## Access Compliance Report Public Rights-of-Way (Curb Ramps)

Intersection ID: 13057 Main Street: E\_MOREHEAD\_ST Cross Street: S\_COLLEGE\_ST Location: SW

ADA ID: E433818DB916 Ramp Type: PerpDiag Initial Pass/Fail: Fail Overall Compliance: No Severity Score: 16.25

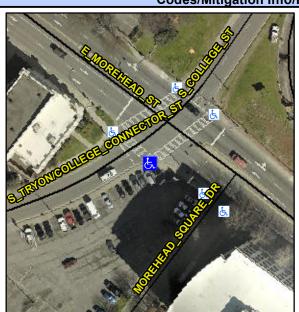
PROW/ADA:
Not Found, R304.5.3, R302.7

Remove & Replace Curb Ramp With
Two New Directional Ramps or
Equivalent.
